Metropolitan Historic Zoning Commission
Sunnyside in Sevier Park
3000 Granny White Pike
Nashville, Tennessee 37204
Telephone: (615) 862-7970
Fax: (615) 862-7974

STAFF RECOMMENDATION
404 North 17th Street
March 20, 2019

Application: New Construction—Addition and Outbuilding/Detached Accessory Dwelling Unit; Demolition—Outbuilding
District: Lockeland Springs-East End Neighborhood Conservation Zoning Overlay
Council District: 06
Base Zoning: R6
Map and Parcel Number: 08310004000
Applicant: Lynn Taylor, Taylor Made Plans
Project Lead: Melissa Baldock, melissa.baldock@nashville.gov

Figure 3 (left) is the existing shed to be demolished. Figure 4 (right) is the 1957 Sanborn map which does not show the existing shed. The garage shown on this map is no longer extant.

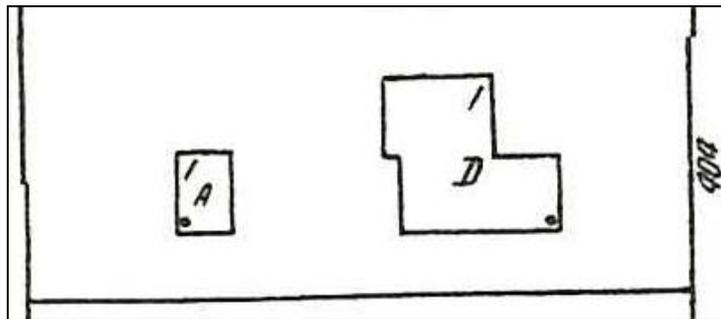
Demolition: The applicant proposes to demolish a shed at the rear, right side of the lot (Figure 3). The date of construction of the shed is unknown, but it does not appear on the 1957 Sanborn map (Figure 4). It is seen in the c. 1968 property assessor photo, so it was likely constructed between 1957 and 1968 (Figure 5). Staff finds that the shed's date of construction and architectural integrity do not contribute to the historic character of 404 North 17th Street or to the Lockeland Springs-East End Neighborhood Conservation Zoning Overlay.

Staff therefore finds that the demolition of the shed demolition meets Section III.B.2 for appropriate demolition and does not meet section III.B.1 for inappropriate demolition.

Figure 6 (left) is the existing front stoop. Figure 7 (right) is the 1951 Sanborn map, which does not show a porch element.

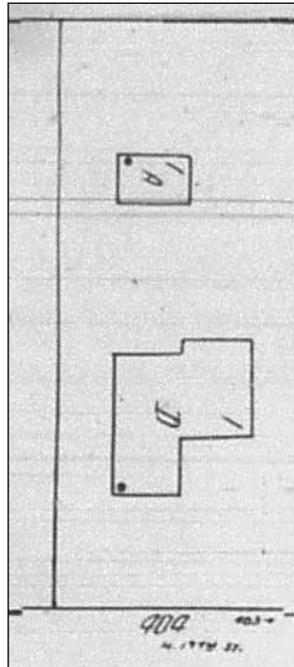
The drawings also show an expanded front porch. The existing house has a covered stoop (Figure 6). There is no evidence that the house originally had a front porch or a stoop larger than what is existing. The 1951 Sanborn Map does not show a porch element (Figure 7). In addition, the c. 1968 Property Assessor photo shows a similar stoop configuration to what is existing (see Figure 5). Since adding elements to the front of the house that were not there originally does not meet the design guidelines, staff recommends that the porch stoop not be expanded into a wider front porch.

Location & Removability: As mentioned under “Height and Scale,” staff finds that the proposed front porch addition does not meet the design guidelines, as there is no evidence that there was a front porch historically. Staff finds that the remainder of the addition is located behind the historic house, leaving the front historic house intact. The addition is designed to be lower in height than the historic house and is inset appropriately. The addition could therefore be removed in the future without affecting the historic integrity of the historic house. With the condition that the front porch not be added, staff finds that the addition’s location and removability to meet Sections II.B.2.a. and II.B.2.d. of the design guidelines.

1. The existing front stoop remain and no front porch element added;
2. There be a minimum of ten feet (10') in between the back of the house/addition and the DADU;
3. Staff approve all windows and doors and the roof shingle color prior to purchase and installation; and
4. The HVAC be located behind the house or on either side, beyond the mid-point of the house.

SITE PLAN

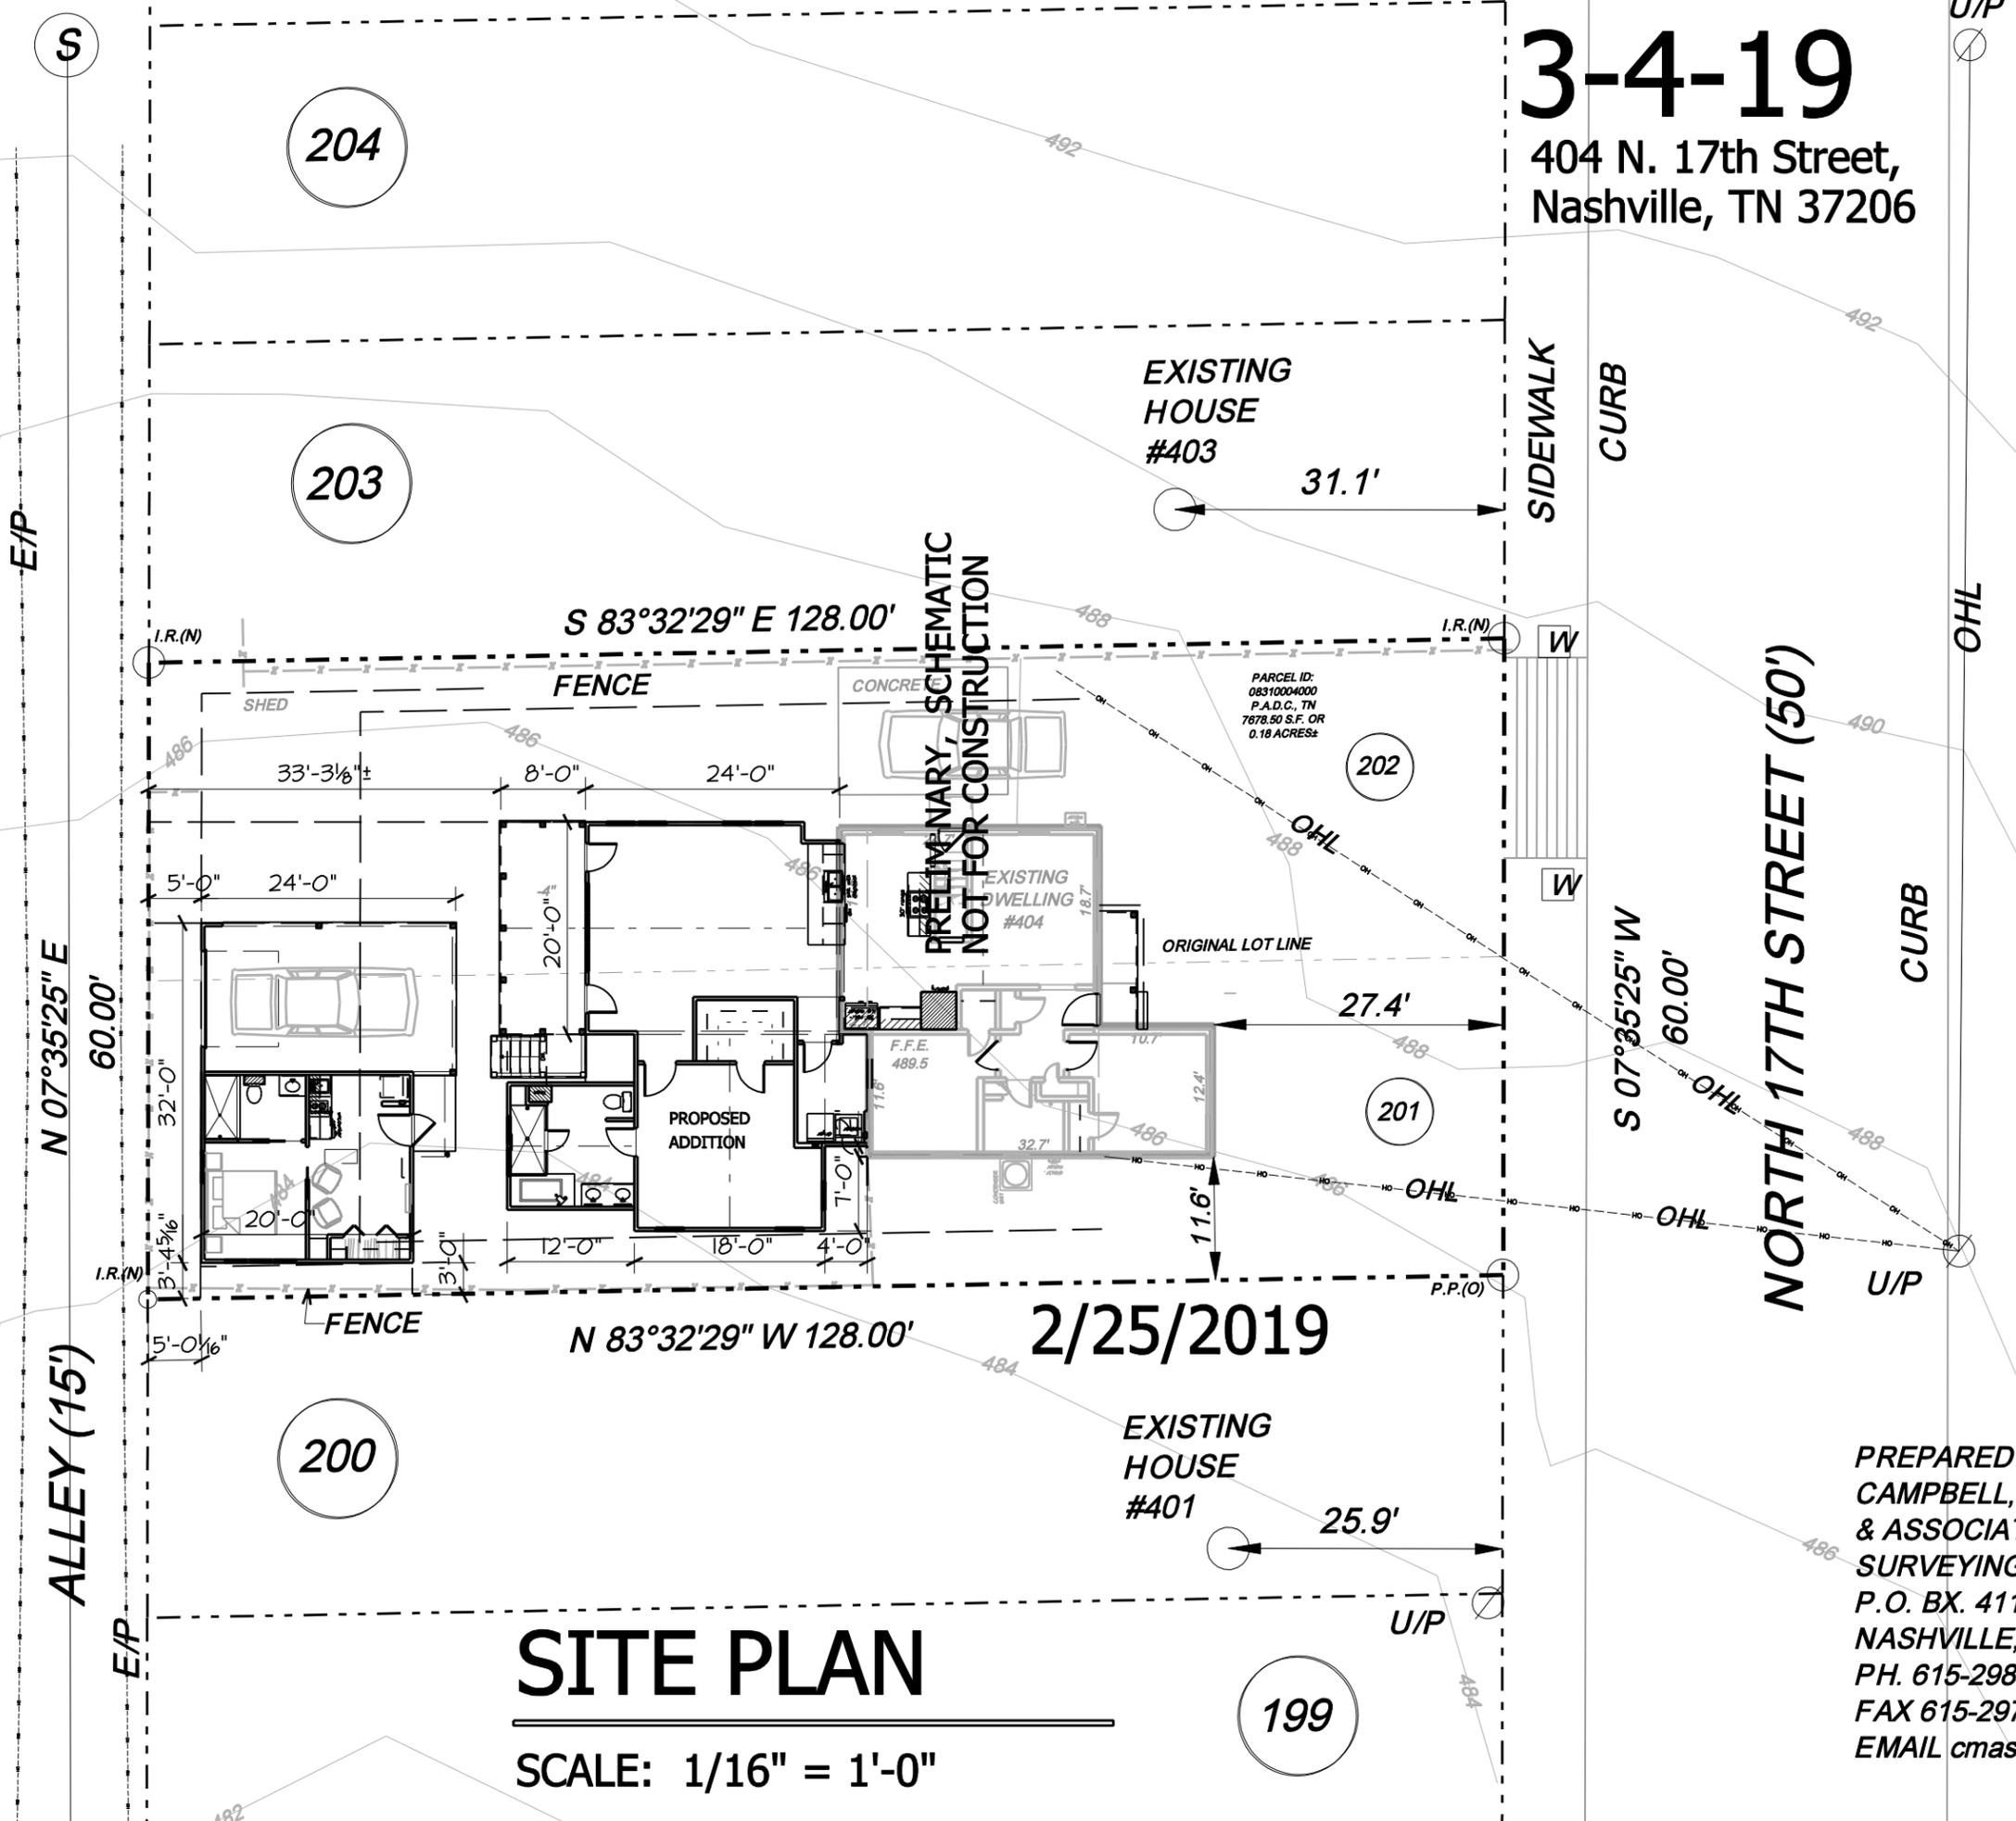
However, staff notes that the addition's depth and footprint, when combined with the proposed DADU, do not allow for adequate separation between the two structures. The policy to require twenty feet (20') between buildings is to meet section II.B.2. for

contextual and to best fit historic development that often included outbuildings at the rear of lots with a great deal of space between a principal building and an outbuilding. In cases where lots are unusually shallow, have constraining easements, or are unusually shaped, the Commission has frequently reduced the depth to ten feet (10'). Because this lot is unusually shallow at just one hundred and thirty feet (130'), staff finds that a reduced distance of ten feet (10') between the back of the house/addition and the DADU could be appropriate. However, the applicant is proposing a distance of between four feet and nine feet (4'-9') between the two structures. Staff recommends that the addition and/or DADU be redesigned so that there is a minimum of ten feet (10') between the two structures in order to meet design guideline II.B.2.

As mentioned under “Height and Scale,” the design guidelines require twenty feet (20’) of space between the back of a house/addition and any outbuilding. In cases where lots are unusually shallow, have constraining easements, or are unusually shaped, the Commission has frequently reduced the depth to ten feet (10’). Because this lot is unusually shallow at just one hundred and thirty feet (130’), staff finds that a reduced distance of ten feet (10’) between the back of the house/addition and the DADU could be appropriate. However, the applicant is proposing a distance of between four feet and nine feet (4’-9’) between the two structures. Staff recommends that the addition and/or DADU be redesigned so that there is a minimum of ten feet (10’) between the two structures.

With the conditions that there be a minimum of ten feet (10') between the back of the house and the DADU and that the front stoop not be expanded into a wider porch, staff finds that the proposed addition meets Sections II.B.1., II.B.2., and II.B.10. of the design guidelines.
